# SERVICE BULLETIN

M-1033

## SUPPLEMENTARY SERVICE BULLETIN FILE WITH SERVICE BULLETIN M-1032 (SAFETY RECALL CODE 082)

Supplementary Service Bulletin M-1033 contains additional information regarding Service Bulletin M-1032 (Safety Recall 082 - Starter Relay).

Figure 1. Typical Heritage-Style Softail Solo Seat

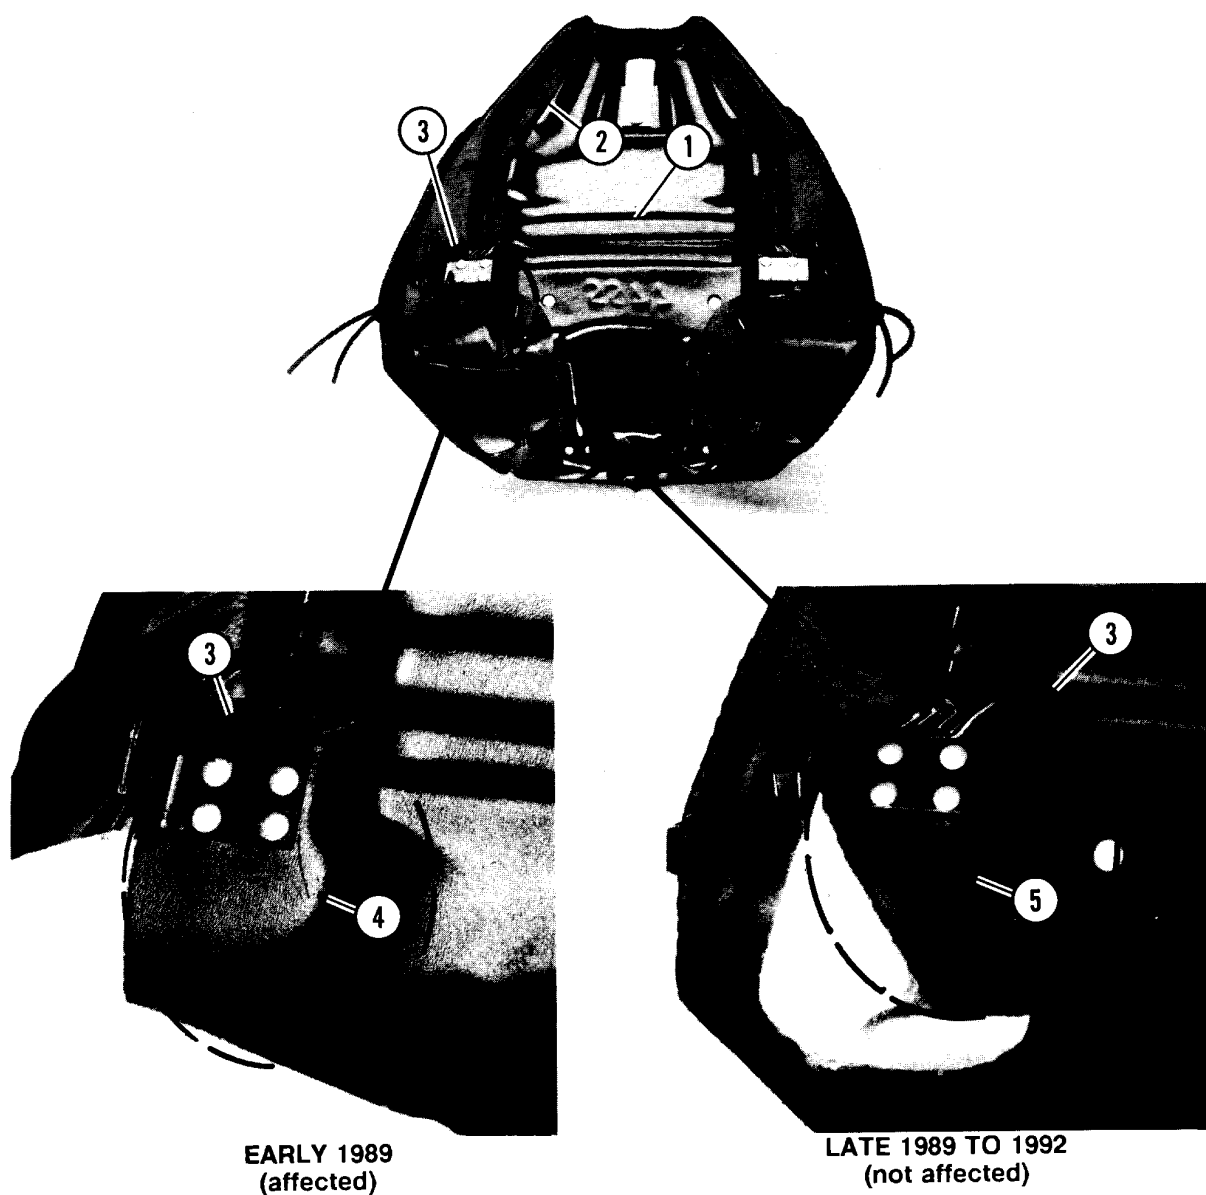
Harley-Davidson has recently learned that there might be inadequate clearance between the motorcycle seat pan (molded plastic underside of seat) and the plastic cover of the new, relocated starter relay **on Early 1989 model year Softail motorcycles**. Late 1989 to 1992 model year Softail motorcycles, which have a seat pan molded in a slightly different shape, should not experience this interference condition when the procedure outlined in Service Bulletin M-1032 is performed on them.

When performing the Service Bulletin M-1032 procedure on a Softail motorcycle, determine if your particular vehicle has an Early 1989 seat by comparing the seat pan with those shown in Figures 1 and 2. Early 1989 seats have a bulge (4) in the raised right rear corner (3) of the seat pan's (1) widest section; the bulge is positioned directly over the relocated starter relay with the seat installed. Late 1989 to 1992 seats have a smaller, flat surface (5) in the raised right rear corner (3) of the seat pan's (1) widest section.

1. See Figures 1 and 2. With seat removed from motorcycle, use a small flat-tip screwdriver to remove staples securing seat cover material (2) to raised right rear corner (3) of seat pan's (1) widest section. You will need to remove a total of about 7 - 9 staples.
2. Lift loose seat cover material (2) away from raised right rear corner (3) of seat pan (1). Wrap aluminum foil over loose seat cover material to hold material away from affected area of seat pan; aluminum foil will also serve as a heat shield to protect seat cover material.

3. Use an electric forced-air heat gun to heat carefully the bulge (4) area of seat pan's (1) right rear corner (3). Hold heat gun approximately 1-1/2 to 2 in. (38 to 51 mm) away from surface of plastic. Continuously move heat gun over entire area to be reshaped, thereby heating plastic evenly. Continue to heat affected area until plastic can be deformed (using a small block of wood) without returning to its original shape; at this point, plastic is ready to be reshaped.

4. When plastic in affected area of seat pan is warm enough to reshape, use the end of a small block of wood to press plastic downward and outward until original bulge is reshaped into a flat surface (as shown in Figure 3) like that of Late 1989 to 1992 seat pans.
